WATER QUALITY MEMORANDUM

Utah Coal Regulatory Program

FROM: Keenan Storrar, Hydrologist

RE: Second Quarter 2015 Water Monitoring, Alton Coal Development LLC, Coal Hollow, C/025/0005, Task ID #4909

Figure 1. Well Y-102: Alluvial well in upper Sink Valley to the east of pit 9 in permit area.

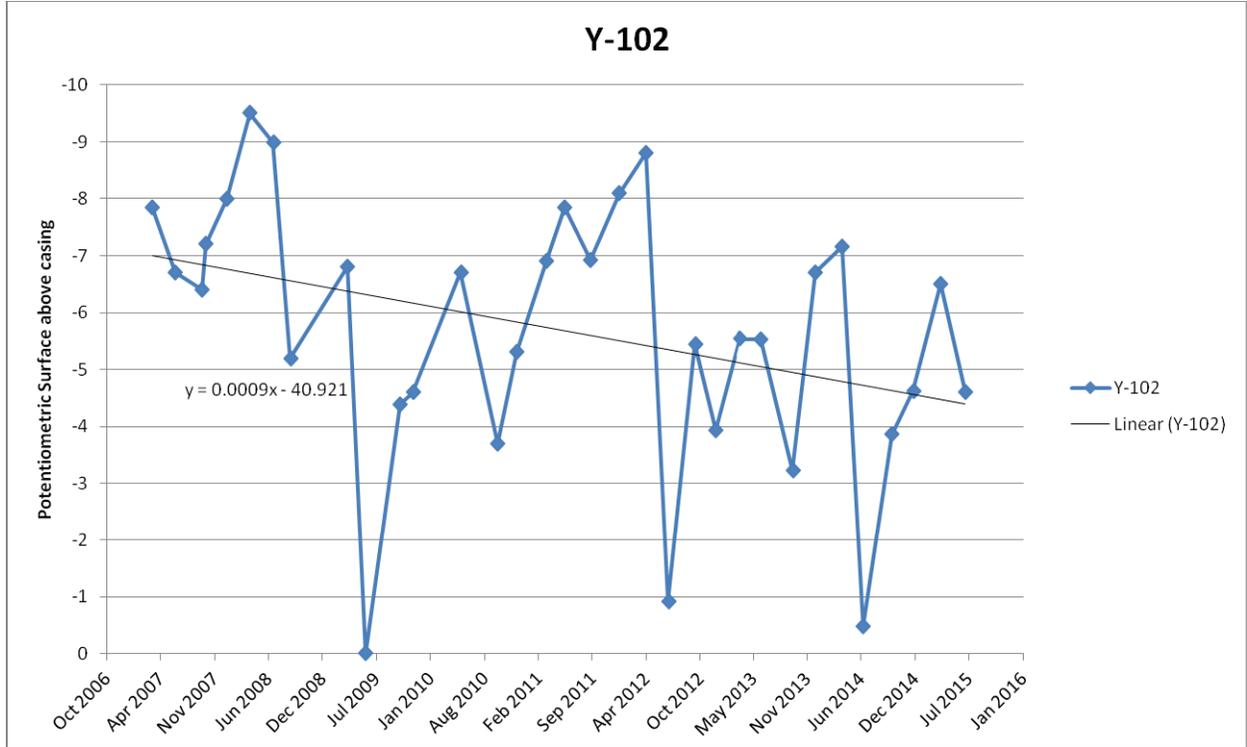
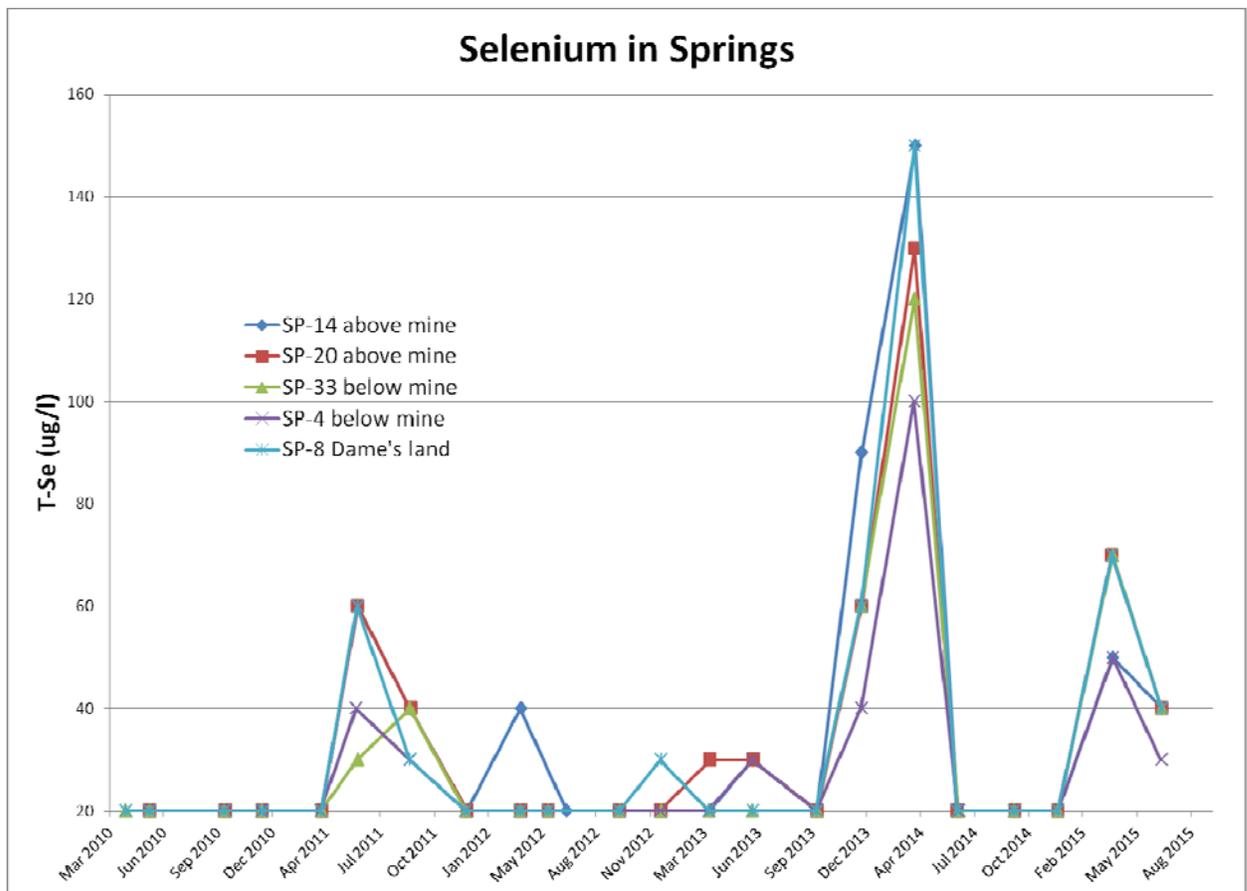
Well 102 is dropping. These levels are dropping because the mine's production well is pumping just up-gradient (Figure 1).

None, however tracking the water elevation in well Y-102 would be worth continued examination. Monitor down gradient wells in Sink Valley and the C-series wells. Continue to monitor elevated selenium in springs, streams, and wells.

Figure 2. Elevated Selenium levels at Spring, Stream, and Well locations through Q2 2015. The y-axis is set at the ND limit for measuring Selenium.

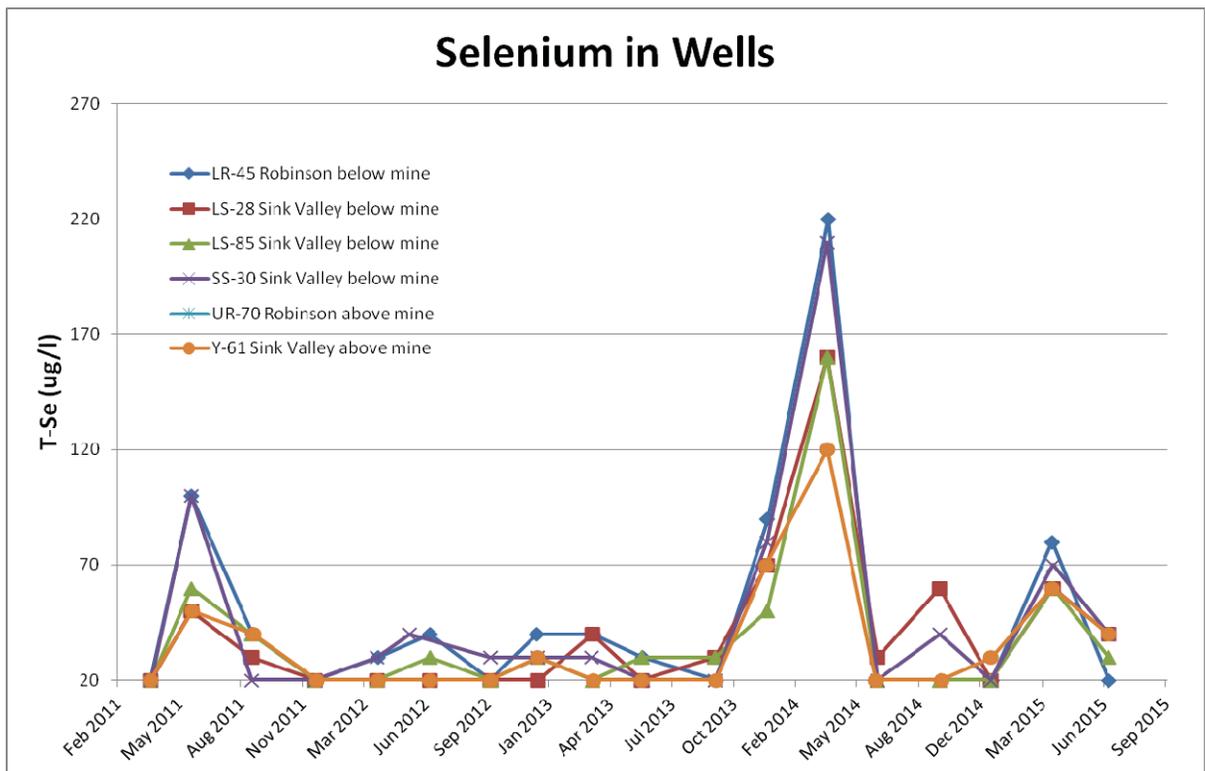
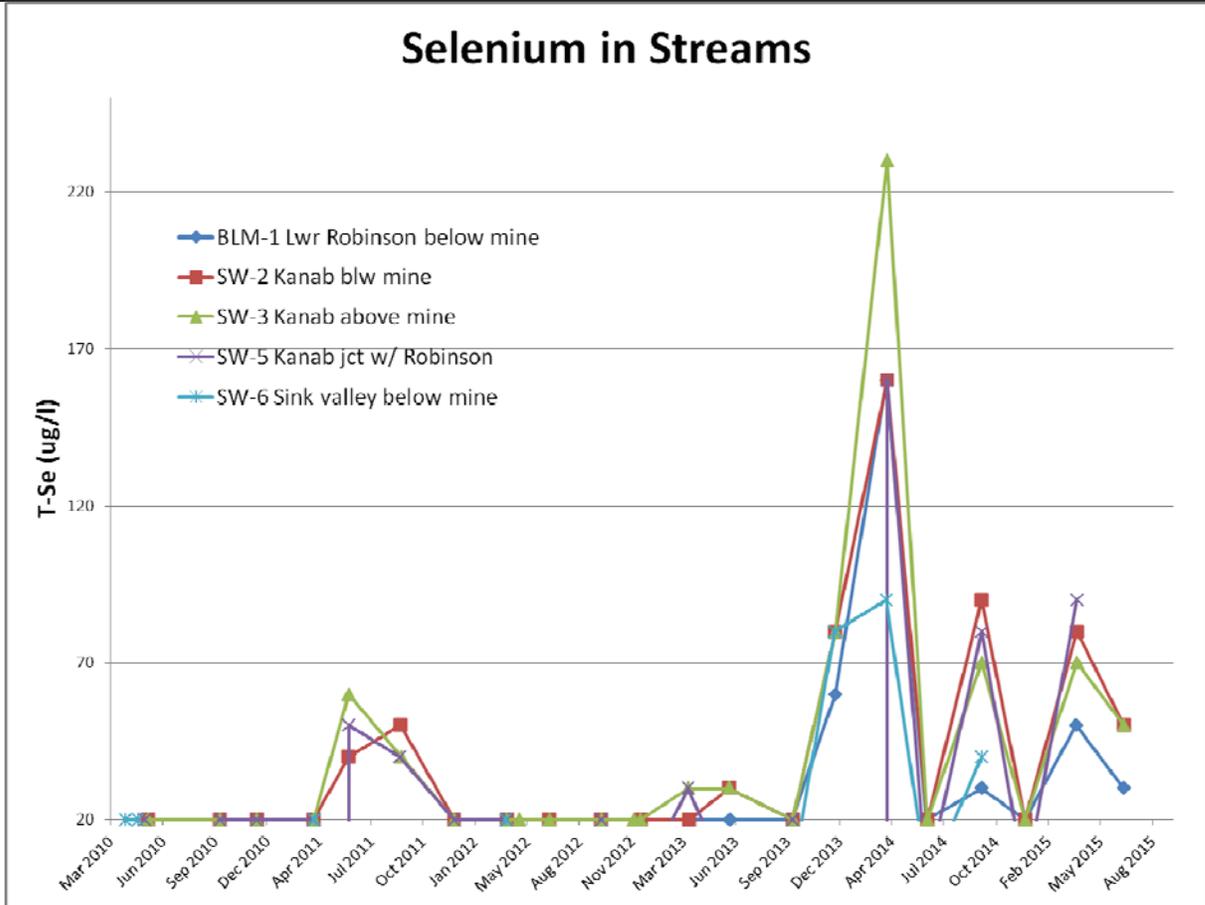
Selenium levels in Kanab Creek may be listed by DWQ as a non-point source pollutant. There have been significant spikes in T-Se in the past few years (see Figure 2). When Chemtech-Ford has a difficult time processing Selenium they show the value as <100, which I ignore.

There have been significant spikes in T-Se levels early in the year that have since gone down.
